Initial technical and cost efficiency assessment of capex expansion plans for Heathrow Airport

Civil Aviation Authority
Our ref: 24949401
Client ref: Contract Ref. 3634

Final report
April 2026

Figure 4.3: Proposed masterplan layout by HAL

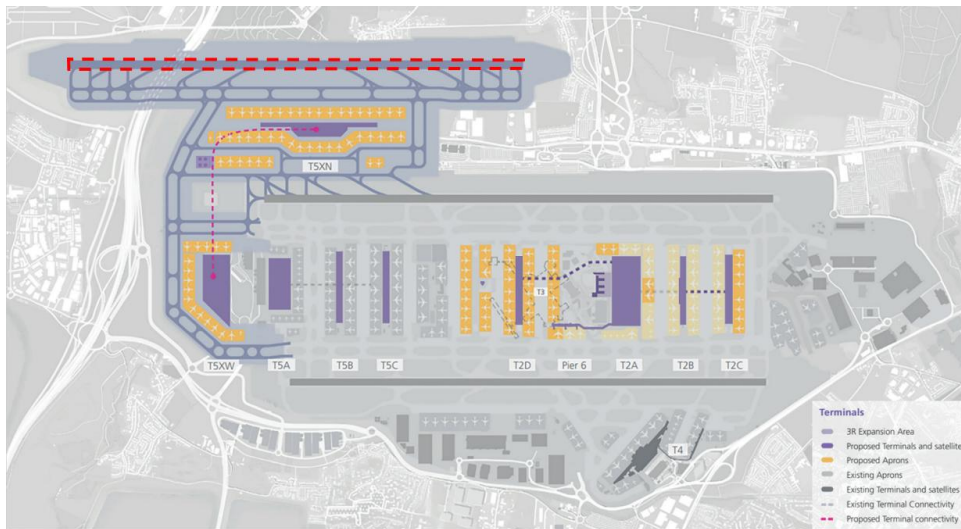
- 4.53 The figure below shows the proposed location of the runway.

Figure 4.5: Relative locations of the three runways options presented by HWL

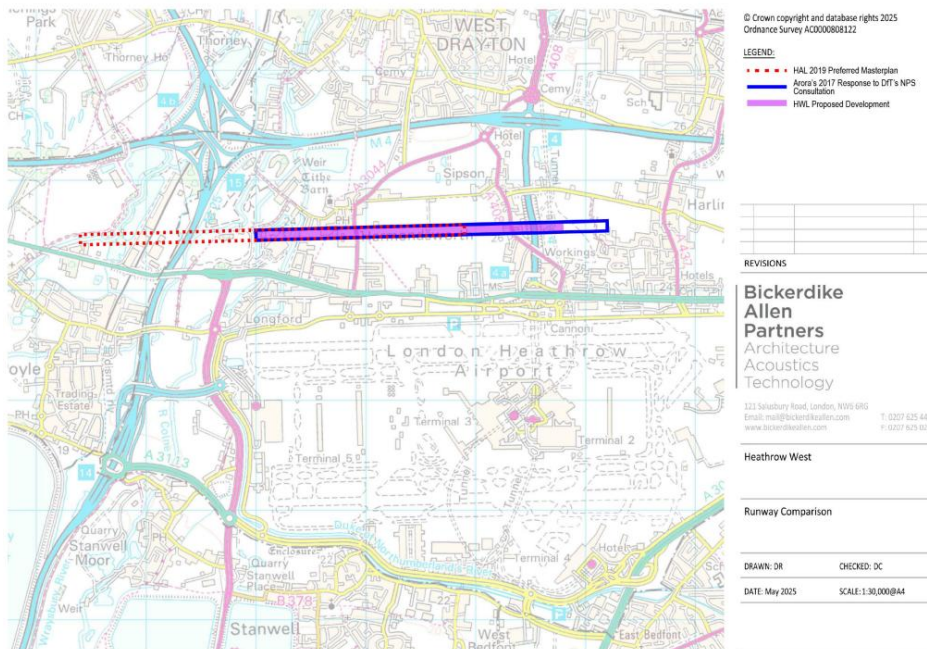
- 4.63 The illustration below shows the options that HWL evaluated, being the pink option the option put forward in their proposal.

Figure 4.7: Steer’s proposed additional road access to Western Campus

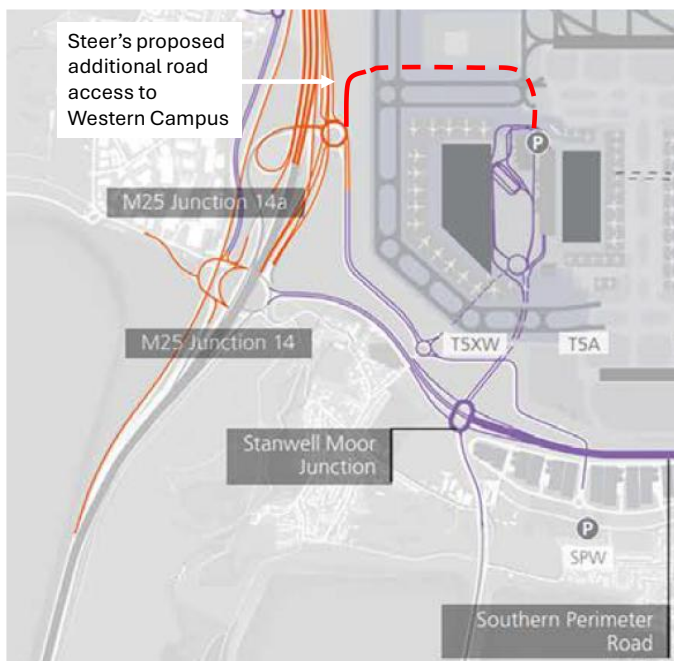
- 4.95 Currently HAL has plans to have road access by the southern side into the West Campus, which will run below the Southern Runway and taxiways. The scheme would significantly improve with an additional northern access. We strongly recommend considering the addition of another road access point into the Western Campus, north of the future T5XW. The image below provides an illustration of the additional road access, marked in red (the dotted line indicates an underground section).

Figure 4.8: Terminal capacity

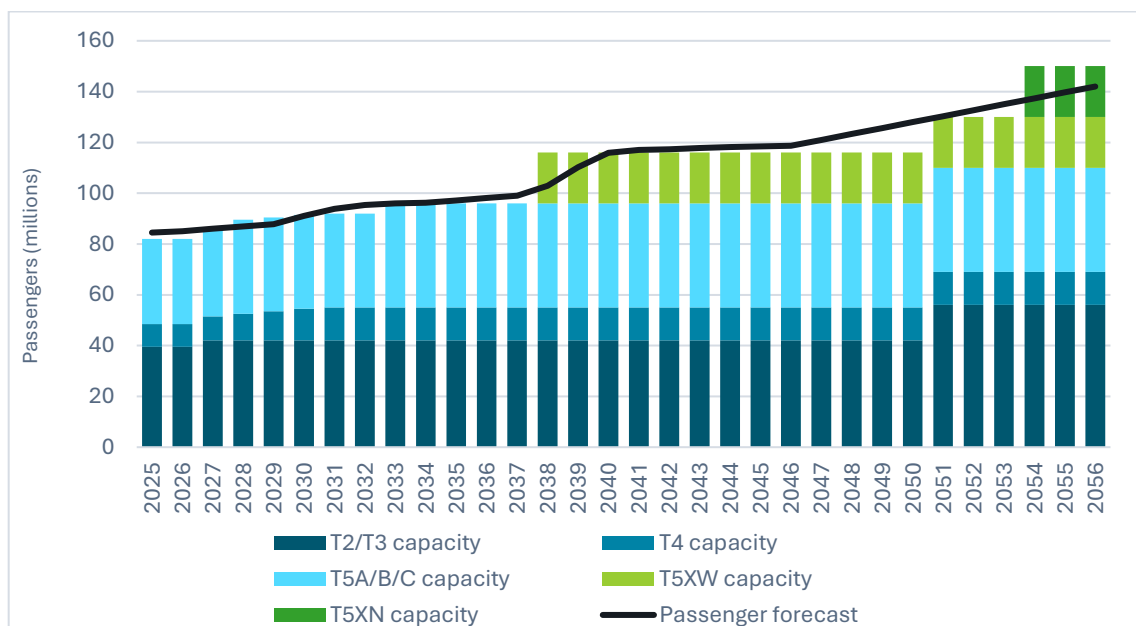
- 4.114 The high-level analysis that we have undertaken with annual passenger numbers concludes that the planned terminal capacity might be sufficient to accommodate the traffic forecast until 2046. From that point, HAL’s proposal shows some terminal capacity shortage. Some investments, such as T5XN, could be brought forward to meet the required terminal capacity demand.

Figure 4.9: HWL's proposed aprons

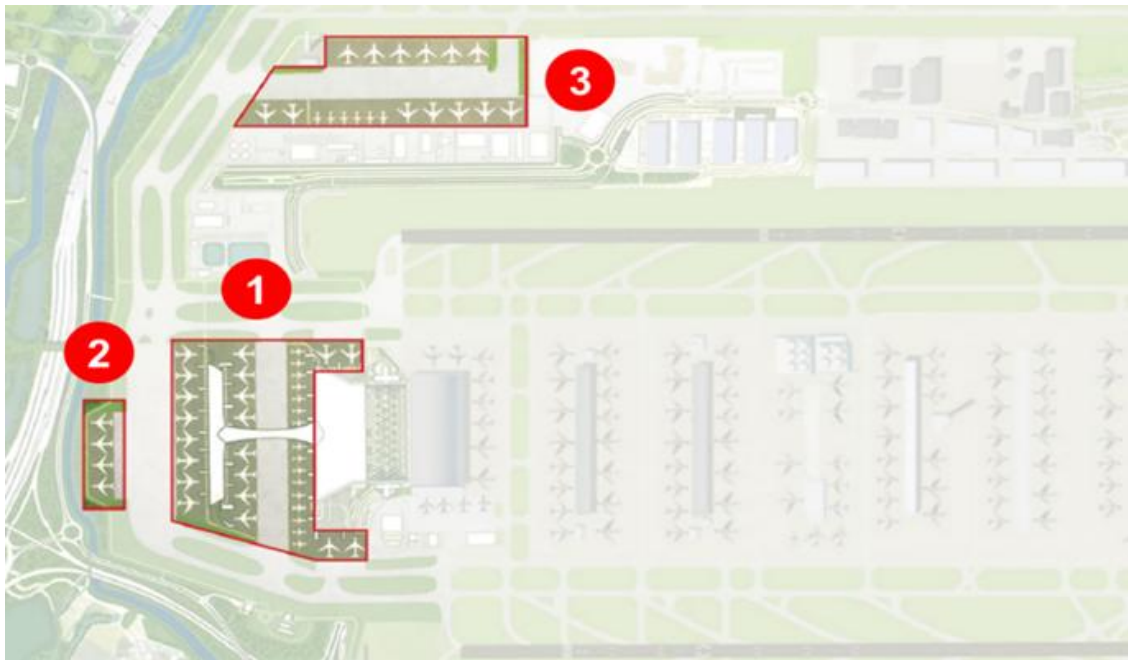
- 4.117 HWL's proposal does not include a thorough justification for the proposed number of stands, as it lacks supporting analysis to demonstrate how the stand capacity corresponds with the forecasted air traffic movements and aircraft fleet composition. The calculated implied capacity ratio of 0.77 mppa per stand is 54% higher than the maximum performance that Heathrow is achieving currently at a terminal level, and 93% higher than the average performance of the airport. With the addition of Apron 3 for day operations, the ratio moves to 0.47 mppa per stand, which is still higher than the current performance and would require an adjustment to factor for the lower efficiency of remote stands. This suggests that additional aircraft parking stand capacity – and potentially more land – may be required to accommodate the projected growth in demand. The figure shows the location of the aprons.

Figure 4.10: Estimated DCO process duration (Steer)

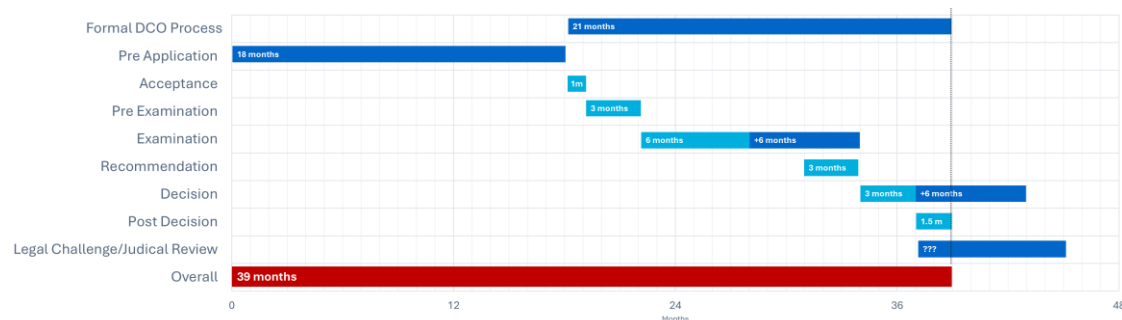
duration in 39 months (18 months for the Pre-Application stage and 21 months for formal DCO process), reflecting more realistic timeframes for each stage based on recent experience. This compares with the 32 months that are assumed by HAL.

Figure 4.11: Estimated duration of HAL’s expansion plan for runway opening (Steer)

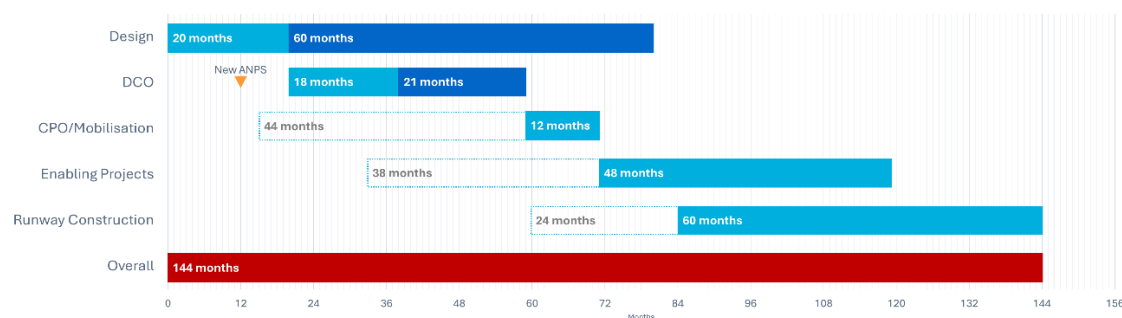
high-level assessment to incorporate some of the above technical observations, including the revised date for the new ANPS being issued (i.e. end of 2026), potential extensions to the DCO process (2 additional months for consultation and 4 months for determination), delays relating to, critical land acquisition requiring CPO (12 months) that impact on key enabling projects allowing for a potential for resequencing works (-3 months), and allowances for construction mobilisation. The resulting alternative timeline is presented below and shows a total timeline duration of 144 months, or 12 years for the opening of the new runway. This is an increase of 15 months from the 129 months outlined in the HAL timeline for the runway opening (Scenario 1).

Figure 4.12: Estimated DCO process duration (Steer)

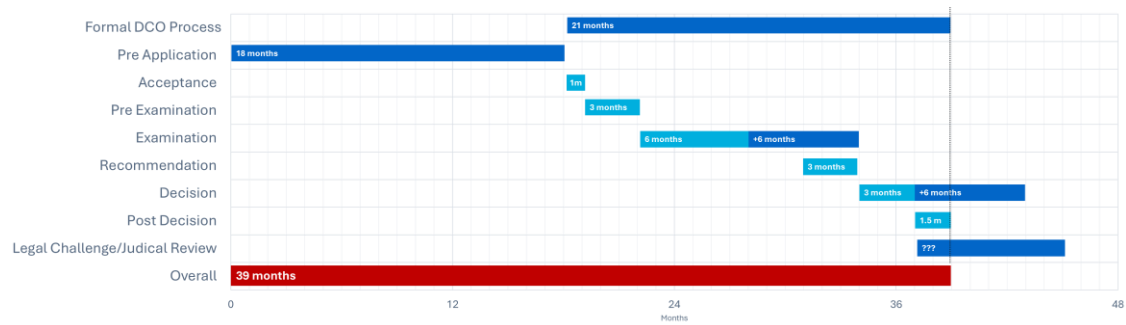
- 4.144 We provide below an estimation for Heathrow’s expansion DCO process, starting from the Pre Application stage (or Preparation and Consultation) and ending with the Post Decision milestone (or Approval granted). We estimate the overall duration is 39 months (18 months for the Pre-Application stage and 21 months for formal DCO process), reflecting more realistic timeframes for each stage based on recent experience. This compares with the 35 months that are assumed by HWL. Although we note that HWL contemplates 7 additional months for preparation work before the revised ANPS is approved, we assess that this work cannot be accounted for Pre-Application stage.

Figure 4.15: Road congestion around Heathrow

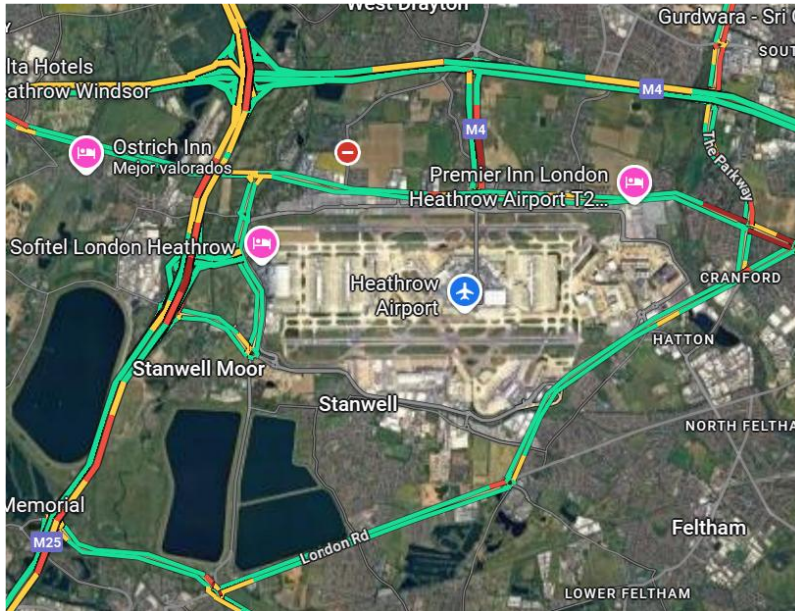
4.195 The current road traffic load in the M25 to the west of Heathrow (near J14) is one of the highest in the UK and has creates material traffic delays every day¹². The figures below show a heat map with the road congestion around Heathrow and the average delays of the M25.

Figure 4.17: Potential development constraints for the expansion of Heathrow and their implications

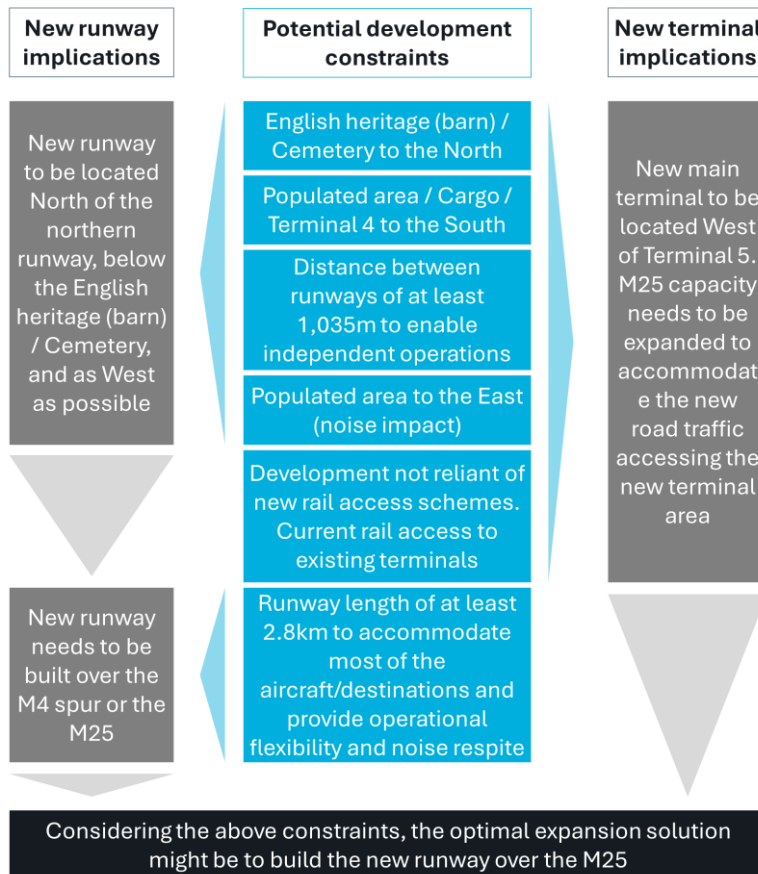
- 4.197 Taking into account the conclusions on runway location and length, and the associated surface access infrastructure, the option of constructing the new runway over the M25 appears to be a plausible solution. This is because, with the main capacity uplift concentrated to the west of the airport, the M25 would already require major works to accommodate increased traffic and new access arrangements. Undertaking the runway construction in this area would therefore consolidate interventions within a single corridor, rather than introducing additional disruption and complexity along the M4 Spur, which would also be affected under alternative configurations.
- 4.198 The diagram below summarises the decision-making process that emerges from the identified development constraints.

Figure 3.13: Steer’s proposed additional road access to West Campus

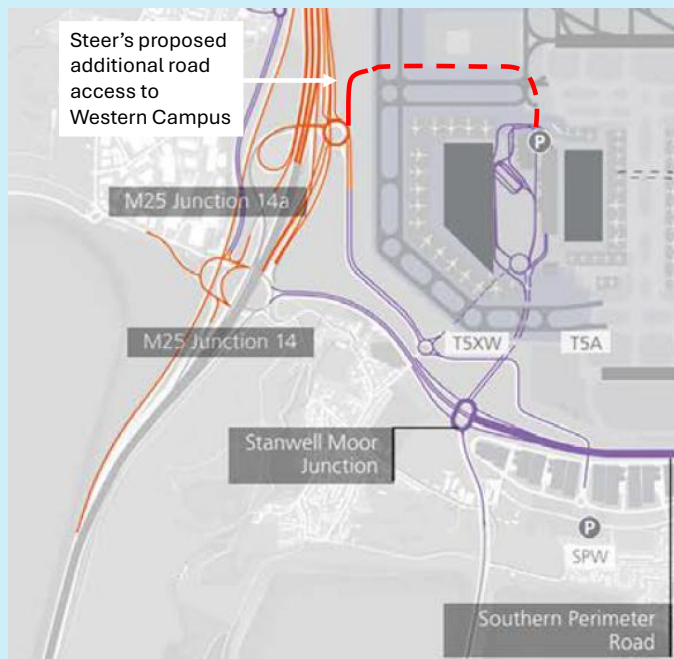
Currently HAL has plans to have road access by the southern side into the West Campus, which will run below the Southern Runway and taxiways. The scheme would significantly improve with an additional northern access. We strongly recommend considering the addition of another road access point into the West Campus, north of the future T5XW. The image below provides an illustration of the additional road access, marked in red (the dotted line indicates an underground section).

Figure 5.3: Estimated DCO process duration

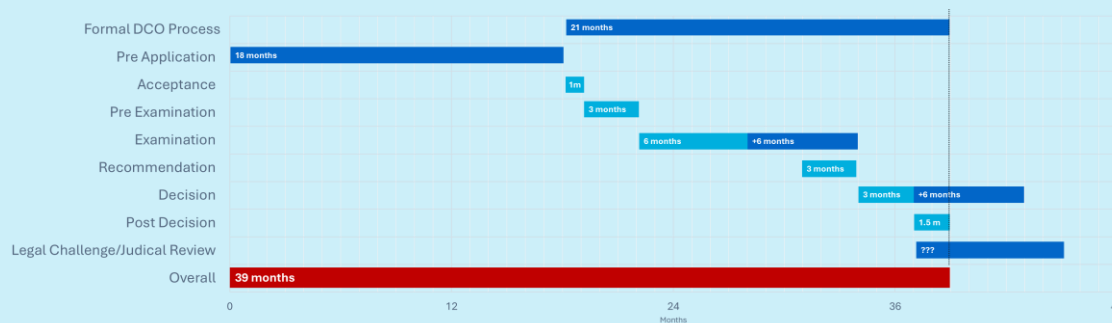
We provide below an estimation for Heathrow’s expansion DCO process, starting from the Pre Application stage (or Preparation and Consultation) and ending with the Post Decision milestone (or Approval granted). We estimate the overall duration in 39 months (18 months for the Pre-Application stage and 21 months for formal DCO process), reflecting more realistic timeframes for each stage based on recent experience. This compares with the 32 months that are assumed by HAL.

Figure 5.4: Estimated duration of HAL’s expansion plan for runway opening

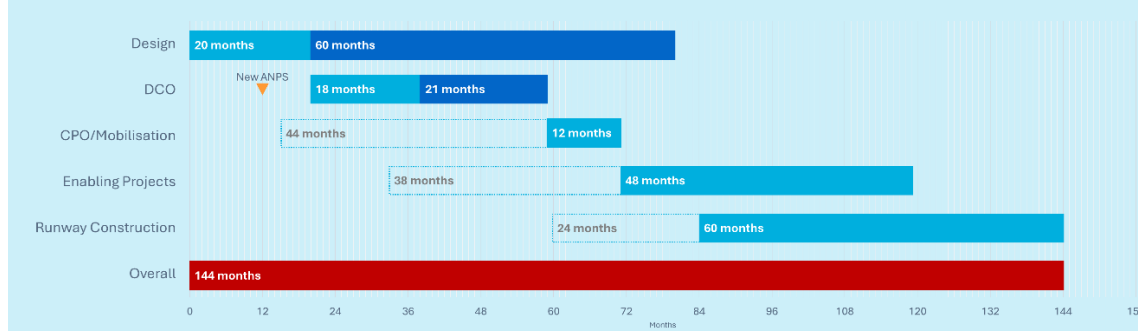
Proposed timeline: A detailed review of the Scenarios 1 and 2 timelines has not been explored by HAL to the same level as the Scenario 3, which forms the basis of their proposal. To test the robustness of HAL’s assumptions, we undertook a high-level assessment to incorporate some of the above technical observations, including the revised date for the new ANPS being issued (i.e. end of 2026), potential extensions to the DCO process (2 additional months for consultation and 4 months for determination), delays relating to, critical land acquisition requiring CPO (12 months) that impact on key enabling projects allowing for a potential for resequencing works (-3 months), and allowances for construction mobilisation. The resulting alternative timeline is presented below and shows a total timeline duration of 144 months, or 12 years for the opening of the new runway. This is an increase of 15 months from the 129 months outlined in the HAL timeline for the runway opening (Scenario 1).
